Informal document GRSP-74-03
GRSP 74th session, 04 – 08th December 2023
Agenda Item 12

Ensuring CRS compliance with UN R129

Submitted by the experts from CLEPA

CRS 1 (EX Type-approval)

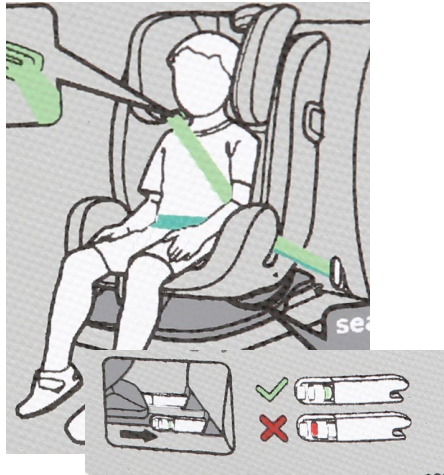
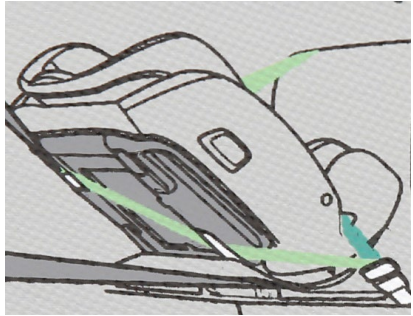
Belt route 1: Belt-attached integral
(Child: 40-105 cm)

Belt route 2: Belt-attached integral
(Child: 100-145 cm)

- Two belt routes (para. 3.2.2)
- Non-ISOFIX attachments (para. 6.1.3.2)
- 'ISOFIX' on belt-attached integral/booster combination (para. 3.2.2.)
